City of Tualatin

ARCHITECTURAL REVIEW DECISION

AR-18-0005

Case #:	AR-18-0005
Project:	Columbia Roofing Building Addition
Location:	18525 SW 126 th Place, Tualatin; Tax Lot 2S1 21A 04200
Applicant/Owner:	Chesshir Architecture, PC/Gray Alfa, LLC
Applicant/Rep.:	Stan Chesshir, Chesshir Architecture, PC, stan@chesshirarchitecture.com

1 REVISED SITE PLAN
 SCALE: 1" = 30'

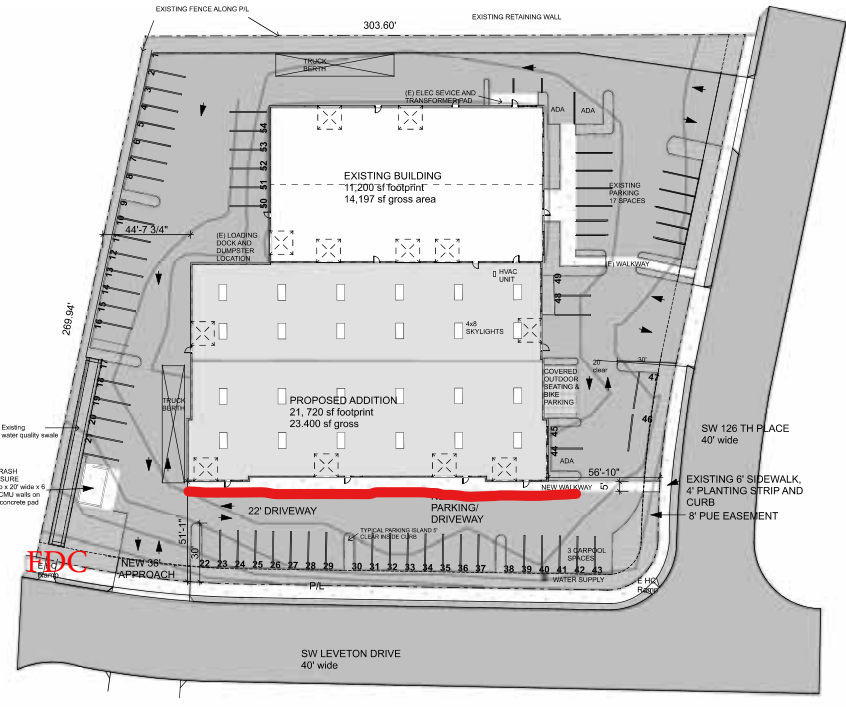
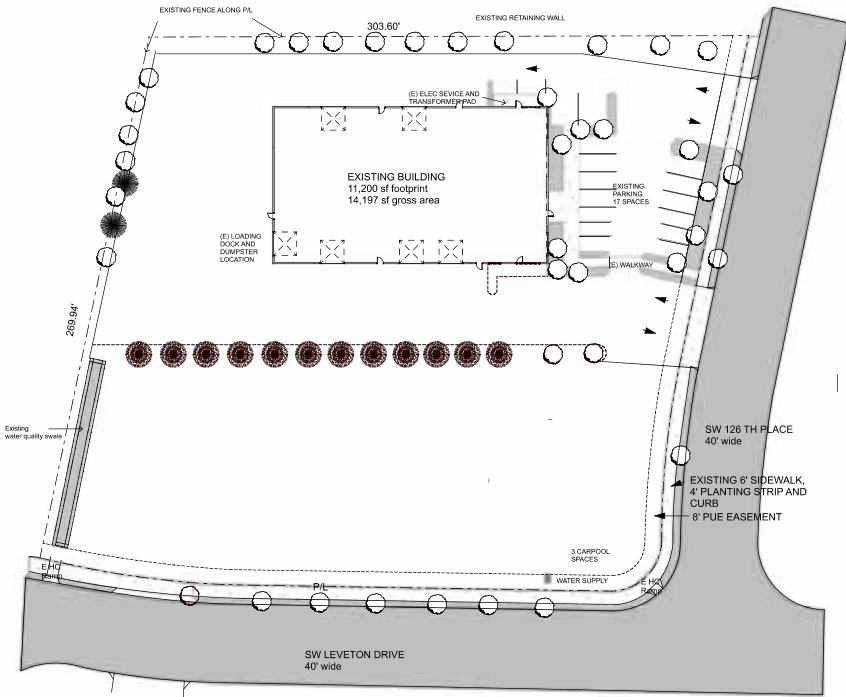
A4 The applicant must revise the Plan Set to include a five-foot-wide (from inside of curb to curb) landscape island north of parking space #54 (as indicated on Sheet A1) to protect parked vehicles from moving vehicles, pursuant to TDC 73.360(4). This landscape island must include one deciduous shade tree that meets the requirements of TDC 73.360(7) and must be planted with groundcover or shrubs, pursuant to TDC 73.360(1).

- A7 The applicant must revise the Plan Set to illustrate that the expanded parking lot will provide a minimum of 58 parking stalls for the site which comply with the dimensional standards set forth in Figure 73-1, pursuant to TDC 73.380(1).
- A8 The applicant must revise the Plan Set to illustrate that the western truck berth be screened from SW Leveton Drive by sight obscuring landscaping, walls, or other means as approved by the City Manager or designee, pursuant to TDC 73.390(3). The western truck berth must also meet the requirements of Figure 73-1 and provide 12 feet of clearance for a one-way drive aisle or 22 feet of clearance for a two-way drive aisle, pursuant to TDC 73.390(6). If these standards are not met, the western truck berth must be removed from the proposal.
- A9 The applicant must comply with the Public Facilities Decision, included as Exhibit B.

Sheet A1 of Exhibit A notes a covered bike parking area is located east of the expansion; however no details are provided. Two exterior wall-mounted lights are proposed on the eastern elevation, near the covered bike parking area. With Condition of Approval A6, these standards are met.

Not all parking features are not dimensioned on Sheet A1 of Exhibit A to determine if proposed parking complies with Figure 73-1 (Exhibit G) requirements. With Condition of Approval A7, this standard is met.

Sheet A1 of Exhibit A labels stalls 42-48 as compact for the expanded parking area. These stalls are illustrated at width of 8 feet and a depth of 15 feet; totaling 11% of proposed parking. This standard is met.

Stall 42 is labeled ADA on Sheet A1; however it does not provide a striped access aisle that leads to an accessible walkway. The applicant will be required to provide one adequate ADA parking stall as part of the building permit review. This standard is met.
